HAN DIEC ADDITION

RE: SUB 2001-104 -- One-Step Final Plat of Han Diec Addition

RE: SUB 2001-104 -- One-Step Final Plat of Han Diec Addition

CASE NUMBER: SUB 2001-104 -- HAN DIEC ADDITION

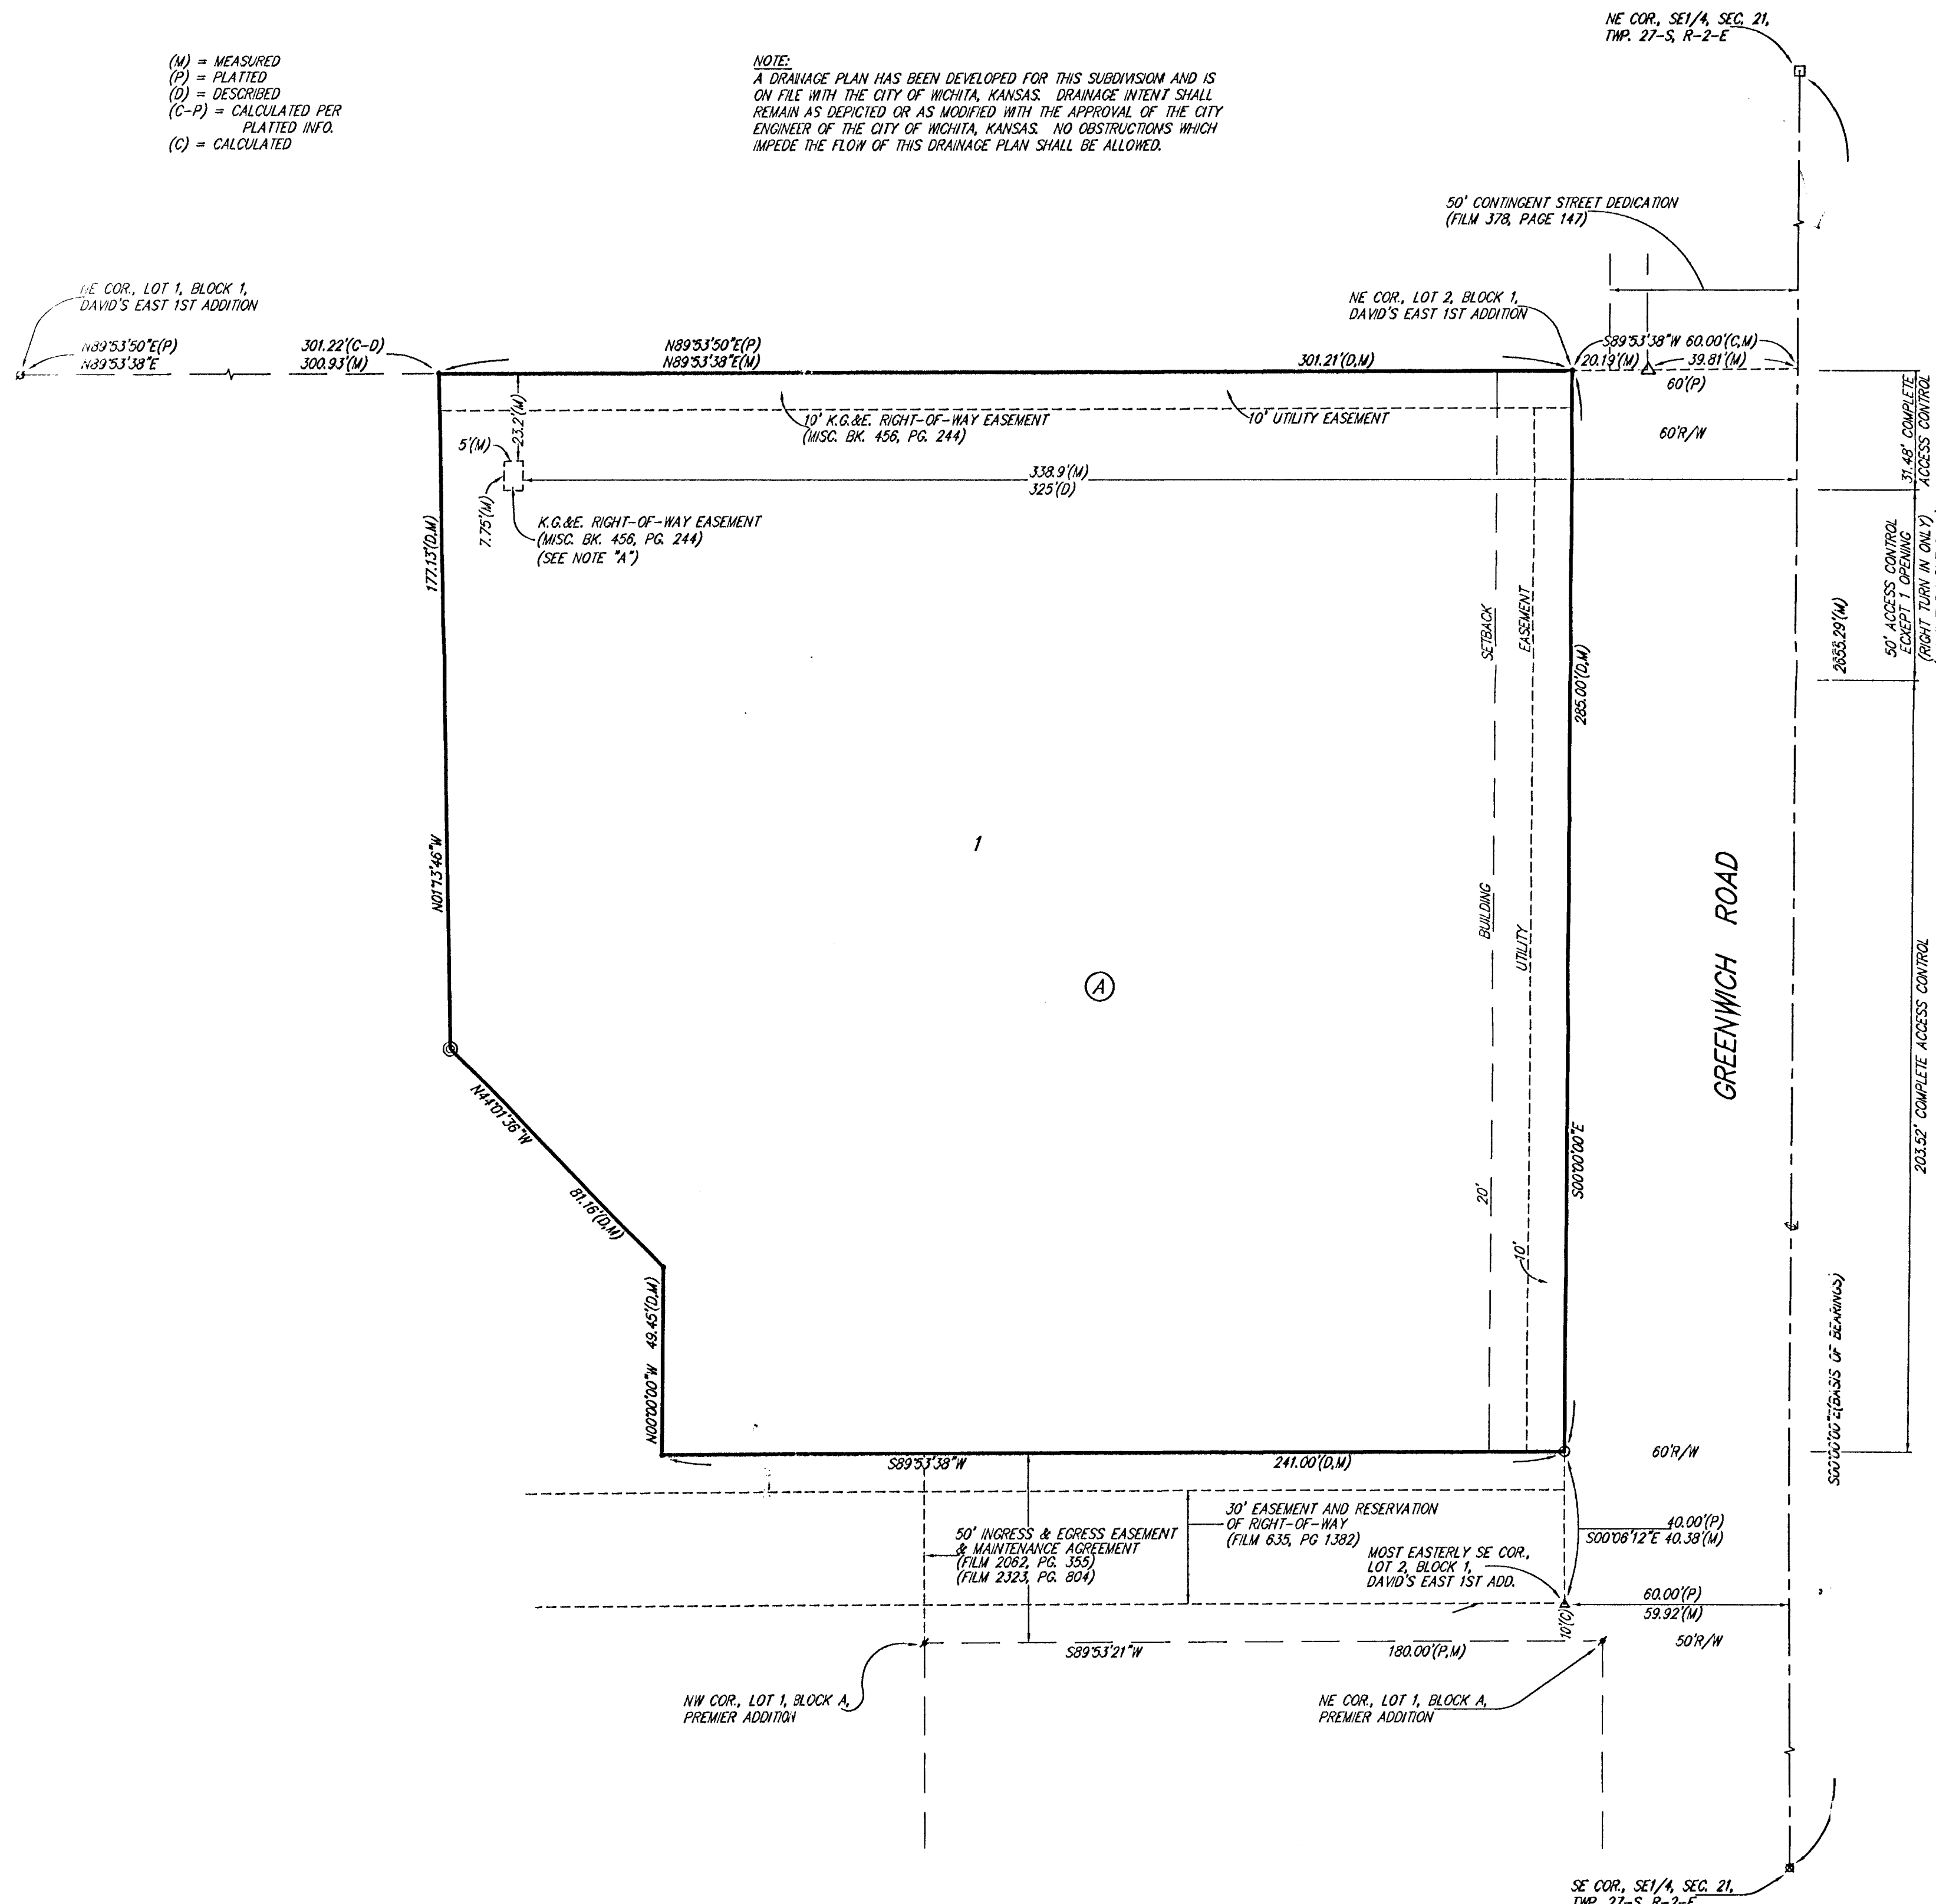
- A. City Engineering needs to comment on the need for guarantees or easements. No guarantees are needed.
- B. If improvements are guaranteed by petition, a notarized certificate listing the petitions shall be submitted to the Planning Department for recording.

- C. City Engineering needs to comment on the status of the applicant's drainage plan. The drainage plan is approved.
- D. The plat proposes one access opening along Greenwich. Traffic Engineering needs to comment on the access controls. Traffic Engineering and MAPD have recommended access control except for one joint opening with the abutting lot to the south. The Subdivision Committee has permitted one access opening to be located 150 feet from the opening for the abutting property to the north.

- E. The applicant shall guarantee the closure of any driveway openings located in areas of complete access control or that exceed the number of allowed openings.

- F. On the final plat, the MAPC signature block needs to reference "J.D. Michaelis, Chair".
- G. The Applicant is advised that if platted, the building setback may be reduced to 20 feet.

- I. The platting text shall include language that a drainage plan has been developed for the plat and that all drainage easements, rights-of-way, or reserves shall remain at established grades or as modified with the approval of the applicable City or County Engineer, and unobstructed to allow for the conveyance of stormwater.

- Q. The representatives from the utility companies should be prepared to comment on the need for any additional utility easements to be platted on this property. **Southwestern Bell has requested additional easements.**
